UNITED STATES PATENT AND TRADEMARK OFFICE

APPLICATION NO.	FILING DATE	FIRST NAMED INVENTOR	ATTORNEY DOCKET NO.	CONFIRMATION NO.
10/695,061	10/28/2003	Seong-Ho Kim	5649-1168	5437

Office Action Summary	Application No. 10/695,061	Applicant(s) KIM ET AL.	
	Examiner Matthew Landau	Art Unit 2815

DETAILED ACTION***Drawings***

FIG.7

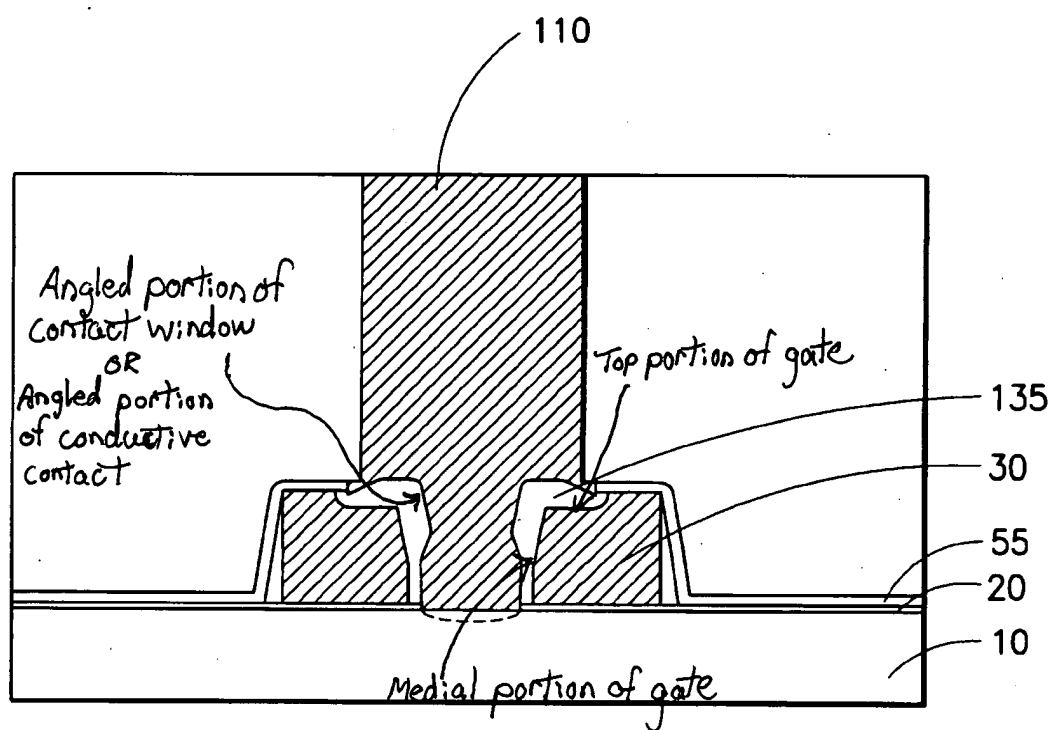
Regarding claim 27, Figure 7 of Wu discloses a plurality of gate electrodes 30 disposed on a substrate 10, the gate electrodes having opposing sidewalls and top and bottom surfaces, wherein portions of selected adjacent sidewalls of neighboring electrodes angle generally downwardly and inwardly toward each other while the opposing sidewall of each of the selected sidewalls are substantially linear, and wherein the angled neighboring sidewall portions have a generally constant downward slope from a top portion of respective gate electrode to about a medial portion thereof, and wherein for a respective selected gate electrode, the opposing sidewall has a different profile shape (i.e., straight). See attached sheet, which further illustrates how Figure 7 of Wu reads on the claimed invention.

Regarding claim 28, Figure 7 of Wu discloses a plurality of elongate contact windows, a respective one positioned between the selected sidewalls of neighboring electrodes 30, wherein the contact window sidewalls comprise an angled profile with an angled portion (see attached sheet) having a generally constant slope that correspond to the angled gate electrode sidewall configuration; and a contact pad 110 disposed in each contact window, the contact pad extending generally downwardly and having a length (height) that is greater than the height of the gate electrode. Note that Wu discloses the device is used in an array (col. 2, lines 3-10); therefore there must be more than one contact.

Regarding claim 29, Figure 7 of Wu discloses a gate protection liner layer 135 that extends in the contact window and covers the angled sidewall portion of a respective gate

electrode; and a first liner layer 55 that covers the remaining surfaces of the top and opposing sidewalls of the respective gate electrode.

Regarding claim 31, Figure 7 of Wu discloses a plurality of gate electrodes 30 disposed on a substrate 10, the gate electrodes having opposing sidewalls and top and bottom surfaces, wherein portions of selected adjacent sidewalls of neighboring electrodes angle generally downwardly and inwardly toward each other while the opposing sidewall of each of the selected sidewalls are substantially linear (see attached sheet); a plurality of elongate contact windows, a respective one positioned between the selected sidewalls of neighboring electrodes 30, wherein the contact window sidewalls comprise an angled profile having a generally constant slope that correspond to the angled gate electrode sidewall configuration (see attached sheet); and a contact pad 110 disposed in each contact window, the contact pad extending generally downwardly and having a length (height) that is greater than the height of the gate electrodes; a gate protection liner layer 135 that extends in the contact window and covers the angled sidewall portion of a respective gate electrode; and a first liner layer 55 that covers the remaining surfaces of the top and opposing sidewalls of the respective gate electrode, wherein the bottom surface of the gate electrodes reside on the semiconductor substrate, and wherein the remaining external surfaces are covered by at least one of the first and second liner layers so that the gate electrodes are encased. Note that Wu discloses the device is used in an array (col. 2, lines 3-10); therefore there must be more than one contact.

Regarding claim 35, Figure 7 of Wu discloses a conductive contact 110 on a substrate 10 in a recess (recess in dielectric layer 60) adjacent to a gate electrode 30 having an opposing top and bottom and a gate electrode sidewall that extends from a top surface to the bottom of the

sidewall, the gate electrode sidewall angling inwardly with a generally constant slope from the top surface to an intermediate portion of the sidewall (middle point of sidewall) toward the recess with a lower portion of the sidewall being substantially vertical so that the bottom of the electrode has a greater width than the top, the conductive contact having a profile with an angled portion having a generally constant slope that corresponds to the slope of the angled gate electrode sidewall and an upper portion that extends above the top surface of the gate electrode. See attached sheet.

Regarding claim 37, Figure 7 of Wu discloses two adjacent gate electrodes 30 on a substrate 10, each gate electrode having a top portion narrower than a bottom portion; a silicon nitride liner 55 covering each gate electrode; and a self-aligned contact pad 110 between the adjacent two gate electrodes, the self-aligned contact pad protruding from a top surface of each gate electrode.

Regarding claim 33, Figure 7 of Wu discloses a gate protection liner layer 135 that extends along the sidewalls of the contact window and covers the angled sidewall portion of a respective gate electrode 30 in the cell array region; and a first liner layer 55 that covers target surfaces of the gate electrodes disposed in the cell array region, wherein the adjacent gate electrode angled sidewall portions merge into respective lower substantially vertical portions.

Applicant argues that Wu does not disclose the newly added limitations. For example, Applicant argues that, "Wu fails to teach or suggest that the angled portion of the sidewall has a generally constant slope from a top surface to an intermediate portion". As explained above, Figure 7 of Wu does disclose all the claimed features. However, as explained in the above rejection (and illustrated in the attached figure), Figure 7 of Wu discloses all limitations of claims 27-29, 35, and 37.
